Access Audit Site Report

Daingerfield State Park

Accessibility Evaluation

Inspection Date: 04/07/2022

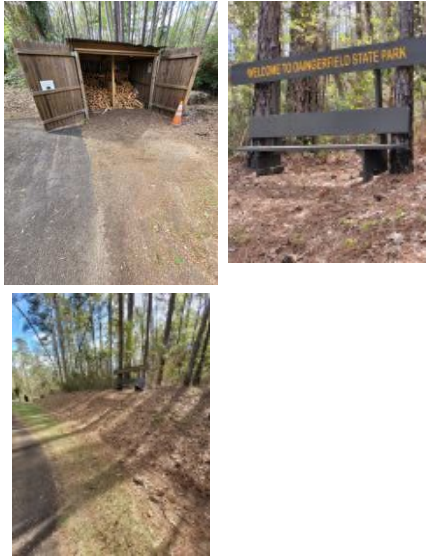
3	Headquarters Area: HQ Parking	[33.0129371 , -94.690708 4]	The cross slopes (narrow dimension) and/or running slopes (long dimension) of the access aisle exceeds 2%. The running slope and the cross slope in an accessible parking stall and the access aisle must not exceed 2%.	Access aisle - 2.3% slope	Repair or correct slope of parking space and access aisle to max 2.08% in any direction.	2015 ABAAS Section: 502.4 2012 TAS Section: 502.4 2010 ADAS Section: 502.4

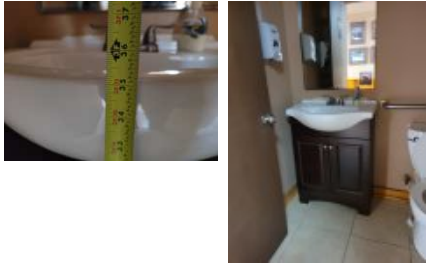
11	Headquarters Area: HQ Public Spaces	[33.012981, -94.690632]	The operable part is not accessible because there is not adequate clear floor space for either a forward or side approach. The clear floor or ground space shall be 30 inches minimum by 48 inches minimum.	Donation box does not have CFS, blocked by table and chair, height ok	Remove, or relocate storage in CFS at fixtures and operable parts along the AR Provide required 30" by 48" CFS at operable parts	2015 ABAAS Section: 305.3 2012 TAS Section: 305.3 2010 ADAS Section: 305.3		
12	Headquarters Area: HQ Public Spaces	[33.0129754, -94.6906306]	The transaction counter is too high. A portion of the counter surface that is 36 inches long minimum and 36 inches high maximum above the finish floor shall be provided. Knee and toe space must be provided for a forward approach. A 30 inch by 48 inch clear floor space on an accessible route must be provided for either a forward or parallel approach.	48" AFF to top of service counter	Lower 36" wide segment of service counter to max 36" AFF	2015 ABAAS Section: 904.4.2, 904.4.1 2012 TAS Section: 904.4.1, 904.4.2 2010 ADAS Section: 904.4.2, 904.4.1

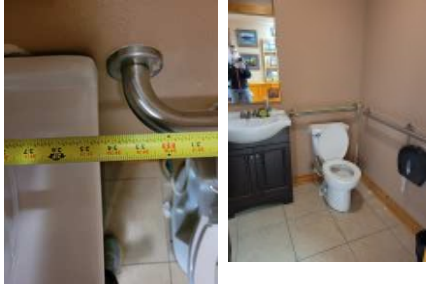
15	Headquarters Area: HQ Public Spaces	[33.0129484, -94.6906521]	There is a gap spaced greater than a 1/2 inch. Openings in floor or ground surfaces shall not allow passage of a sphere more than 1/2 inch diameter. Elongated openings shall be placed so that the long dimension is perpendicular to the dominant direction of travel.	1" gap at bench by entry	Correct or fill gaps to be max .5"	2015 ABAAS Section: 302.3 2012 TAS Section: 302.3 2010 ADAS Section: 302.3

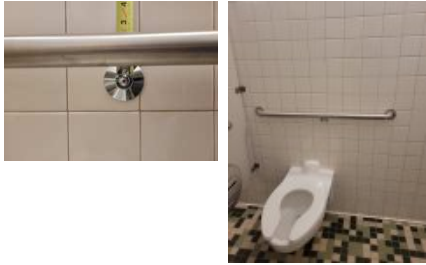
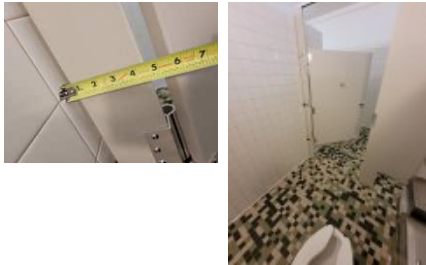
67	Big Pine Camping Area: Big Pine - Men's Restroom	[33.00938, -94.69294]	Where a seat is provided in an alternate roll-in type shower compartment, it shall be a folding type, shall be installed on the front wall opposite the back wall, and shall extend from the adjacent side wall to a point within 3 inches (75 mm) of the compartment entry. In transfer-type showers, the seat shall extend from the back wall to a point within 3 inches (75 mm) of the compartment entry. The top of the seat shall be 17 inches (430 mm) minimum and 19 inches (485 mm) maximum above the bathroom finish floor. Seats shall comply with 610.3.1 or 610.3.2.	Portable bench	Provide the correct seat based on shower type. Cost included in previous finding	2015 ABAAS Section: 610.3 2012 TAS Section: 610.3 2010 ADAS Section: 610.3

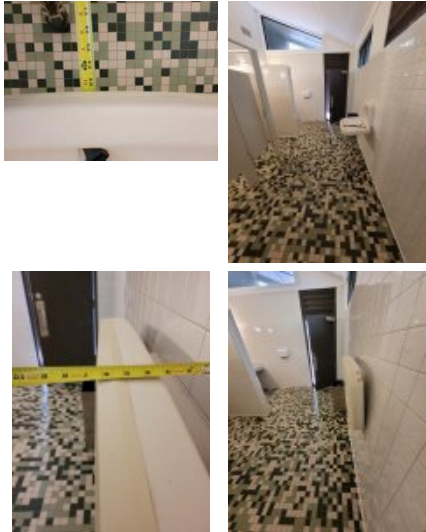
96	Dogwood Camping Area: Dogwood - Sample Campsite	[33.0064526 , -94.691844 3]	Parking spaces and pull-up spaces for recreational vehicles shall be 20 feet (6100 mm) wide minimum. EXCEPTION: Where two adjacent parking spaces are provided for recreational vehicles, one parking space shall be permitted to be 16 feet (4880 mm) wide minimum.	15.5' wide	Correct RV parking space to be 20' wide minimum; or 16' for two adjacent spaces as a smart practice.	2015 ABAAS Section: 1012.2, 1012.2 EXCEPTION

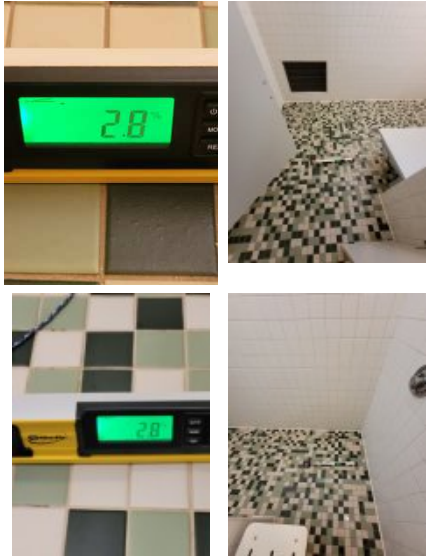
103	Dogwood Camping Area: Dogwood - Men's Restroom	[33.0063457, -94.691462 1]	The grab bar does not extend across the back of the shower In alternate roll-in type shower compartments, grab bars shall be provided on the back wall and the side wall farthest from the compartment entry. Grab bars shall not be provided above the seat. Grab bars shall be installed 6 inches maximum from adjacent walls.	Bars do not extend as required across back of shower	Provide grab bars in the shower mounted in the correct locations for the shower type	2015 ABAAS Section: 608.3.3 2012 TAS Section: 608.3.3 2010 ADAS Section: 608.3.3

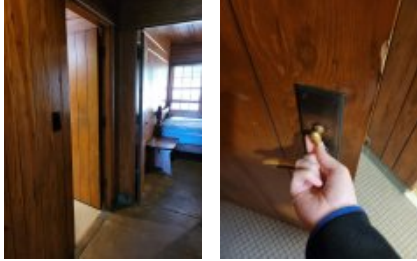
159	Cabins: Cabin - Cabin 3	[33.0090662 , -94.696455]	48 inches (1220 mm) by 48 inches (1220 mm) on all usable sides of the fire ring, grill, fireplace, and woodstove Center the space on each usable side of the grill, fireplace, and woodstove	Grill non-compliant CFS	Provide required 48" clear ground space centered along usable side of fire ring, grill, fireplace, or woodstove as a smart practice	2015 ABAAS Section: 1011.2		
160	Cabins: Cabin - Cabin 3	[33.0090719 , -94.6964537]	Fire building surfaces shall be 9 inches (230 mm) minimum above the ground	Fire ring at ground level	Correct fire building surface to be 9" min above the ground as a smart practice.	2015 ABAAS Section: 1011.5.1

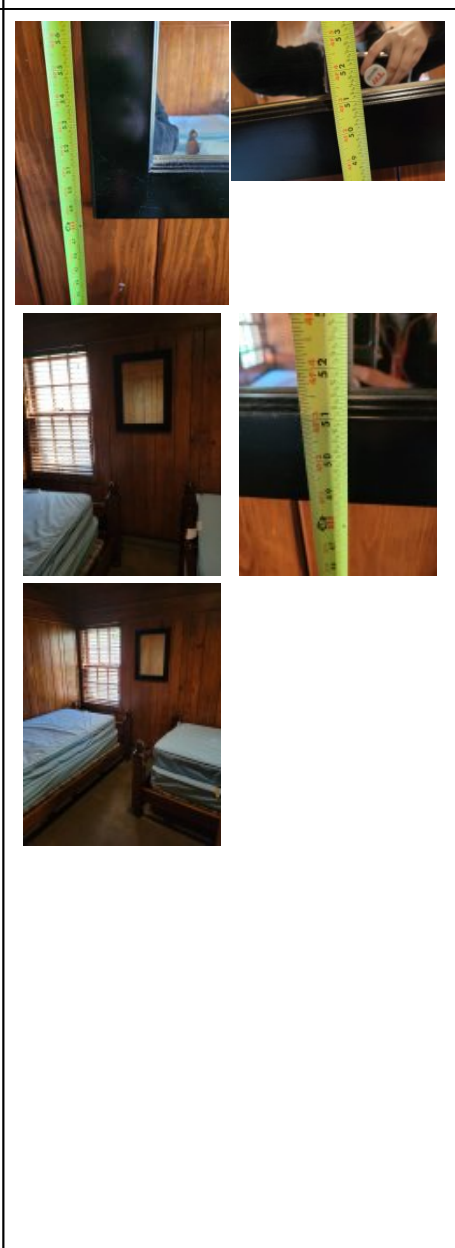
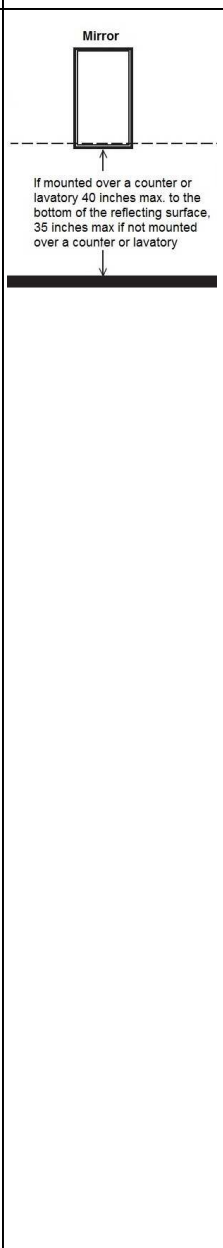
204	Group Lodge: Group Lodge Public Spaces	[33.0086479 , -94.696507 3]	The operable part is not accessible because it requires tight grasping, pinching or twisting of the wrist.	bedrooms on kitchen side- window hardware tight pinch	Replace operable part with one usable without a tight pinch or grasp. Cost included in previous finding	2015 ABAAS Section: 309.4 2012 TAS Section: 309.4 2010 ADAS Section: 309.4

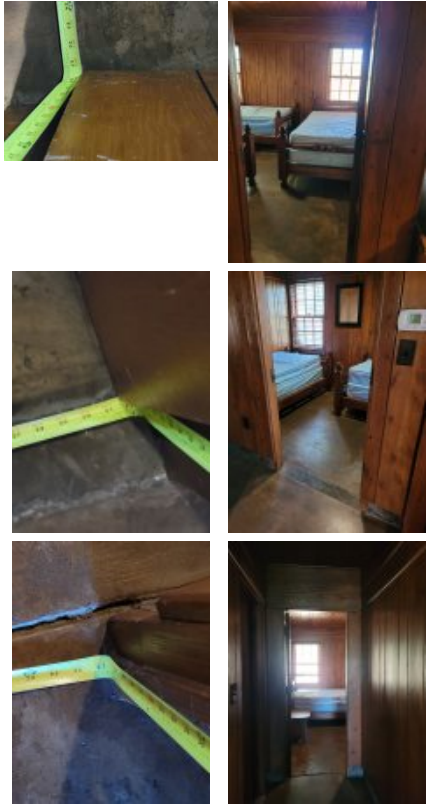
207	Group Lodge: Group Lodge Public Spaces	[33.0086602 , -94.69651]	The controls are located such that operation require reaching across burners. Where knee and toe space is provided, the underside of the range or cooktop shall be insulated or otherwise configured to prevent burns, abrasions, or electrical shock. The location of controls shall not require reaching across burners	Oven controls require reach over	Replace oven with one having controls on the front panel	2015 ABAAS Section: 804.6.4 2012 TAS Section: 804.6.4 2010 ADAS Section: 804.6.4		
208	Group Lodge: Group Lodge Public Spaces	[33.0086467 , -94.696506]	Combination refrigerators and freezers shall have at least 50 percent of the freezer space 54 inches (1370 mm) maximum above the finish floor or ground. The clear floor or ground space shall be positioned for a parallel approach to the space dedicated to a refrigerator/freezer with the centerline of the clear floor or ground space offset 24 inches (610 mm) maximum from the centerline of the dedicated space.	Reduced clearance, 43" due to table and trash	Relocate items for required CFS at refrigerator.	2015 ABAAS Section: 804.6.6 2012 TAS Section: 804.6.6 2010 ADAS Section: 804.6.6

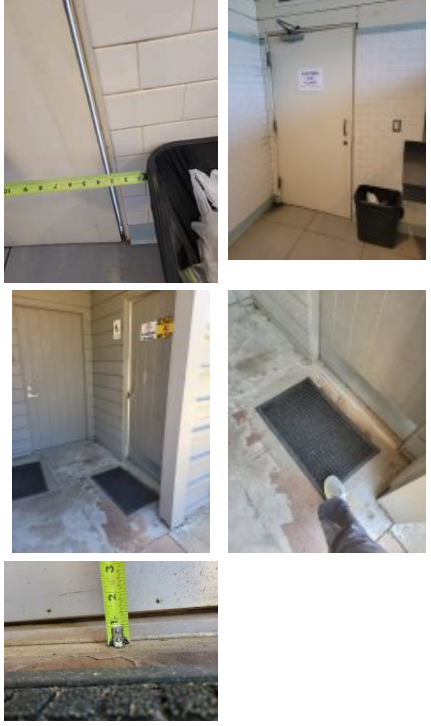
265	Day Use Area: Day Use -Store	[33.0087491 , -94.698630 3]	The door operating hardware is not located within the compliant range. Hand-activated door opening hardware, handles, pulls, latches, locks, and other operating devices on accessible doors shall have a shape that is easy to grasp with one hand and does not require tight grasping, tight pinching or twisting of the wrist to operate. Hardware shall be centered between 34 inches and 48 inches above the floor.	store entry- hardware at 33" AFF	For all doors along the public circulation route, replace hardware with lever hardware where indicated, mounted 34" to 48" aff	2015 ABAAS Section: 404.2.7 2012 TAS Section: 404.2.7 2010 ADAS Section: 404.2.7
